TECHNICAL EVALUATION REPORT

HYDROLOGICAL CONSIDERATIONS (SEP, II-3.A, E

JERSEY CENTRAL POWER AND LIGHT COMPANY
OYSTER CREEK NUCLEAR POWER PLANT

NRC DOCKET NO. 50-219

Figure 3. Site Layout

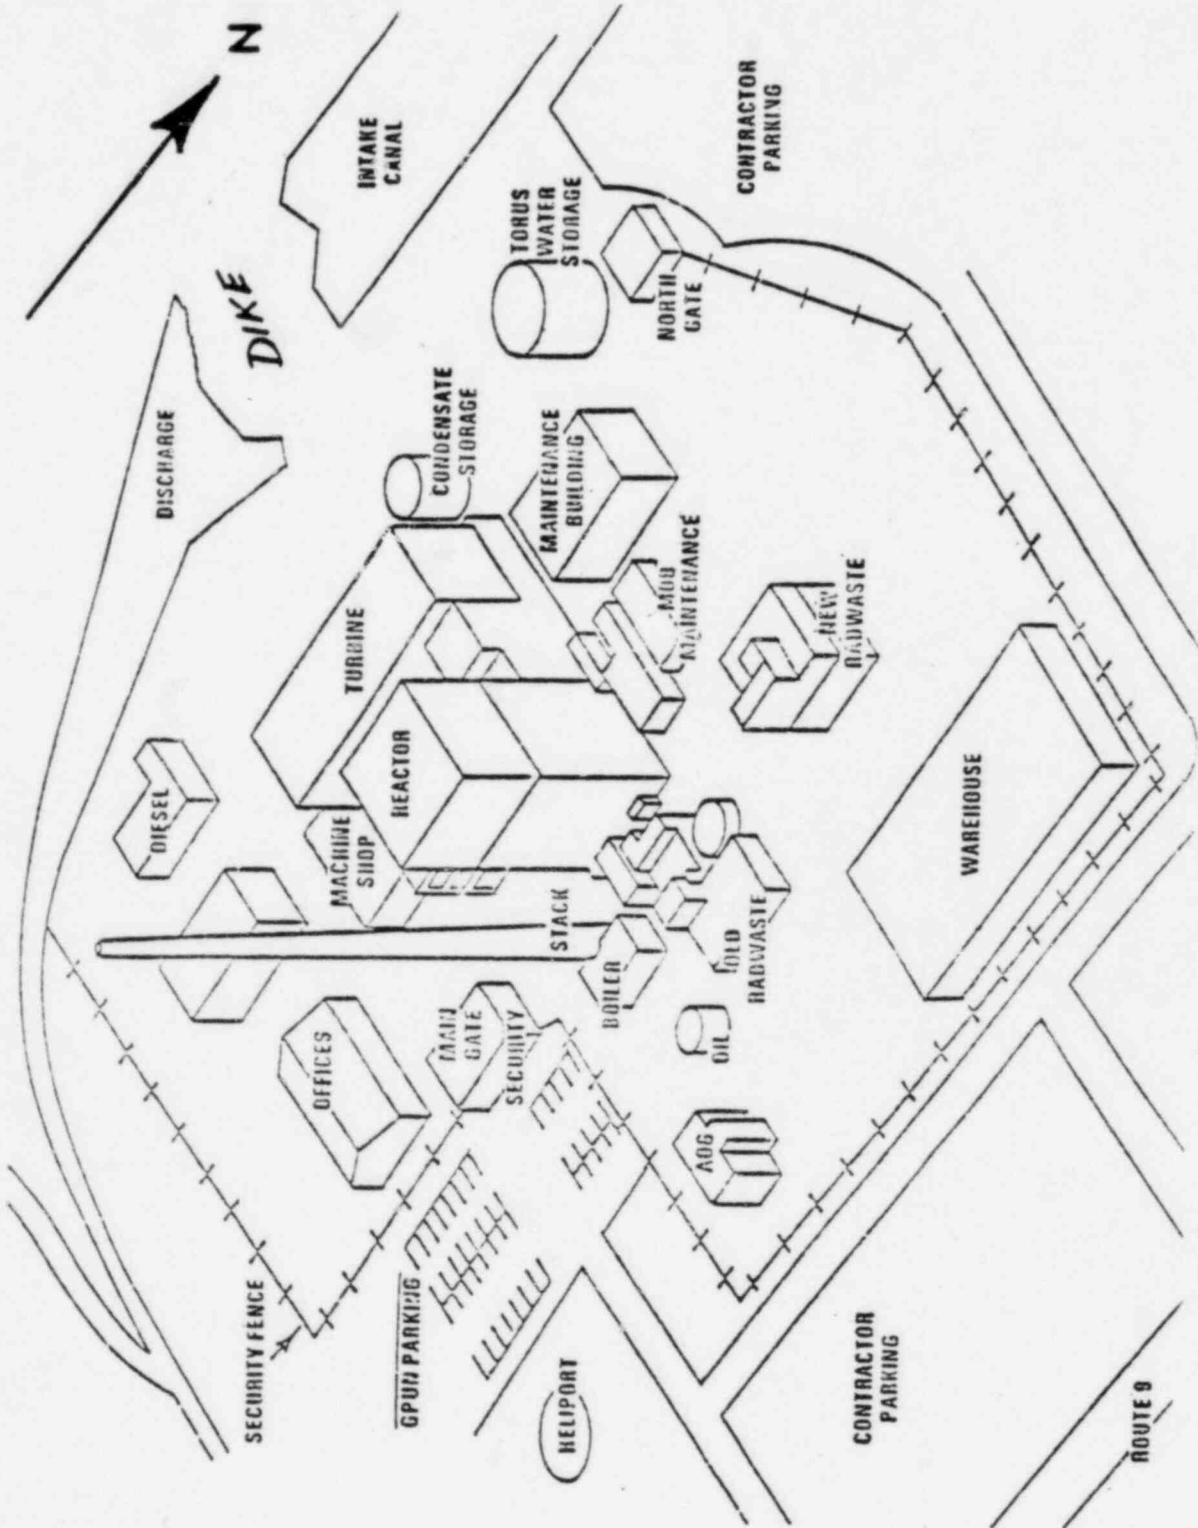
The plant structures (see Figure 3) were designed to withstand the hydrostatic and uplift pressures of groundwater to the following levels:

<u>Structure</u>	<u>Design Basis Groundwater Level (feet msl)</u>
Reactor building	15.0
Turbine building	15.0
Old and new radwaste buildings	No hydrostatic loads applied
Intake structure foundation	3.0
Pipe tunnels connecting old and new radwaste buildings	22.0
New radwaste building, offgas building, boiler house, and others with foundation mat at 23 feet msl	No hydrostatic pressure

Since the duration and exact location of well readings are not specified, nor were estimates made of water table rise due to recharge from local precipitation, groundwater should be assumed to rise to plant grade under some conditions, and all structures should be protected against hydrostatic and uplift pressures to grade elevation, which can be referred to as the probable maximum groundwater elevation. The short duration of high groundwater levels does not affect the conclusion that structures should be designed to withstand the resulting short duration hydrostatic loads.

Plant grade elevation is above the original design basis groundwater elevation for the reactor and turbine buildings, the intake structure foundation, and pipe tunnels connecting the old and new radwaste buildings. Design level is not specified for the emergency diesel generator building (see Section 3.1.3 for design bases). Therefore, the adequacy of the Oyster Creek plant safety-related structures to withstand groundwater level at plant grade cannot be certified under this topic. SEP Topic III-3.A, Effects of High Water Levels on Safety Related Structures, should address this subject.
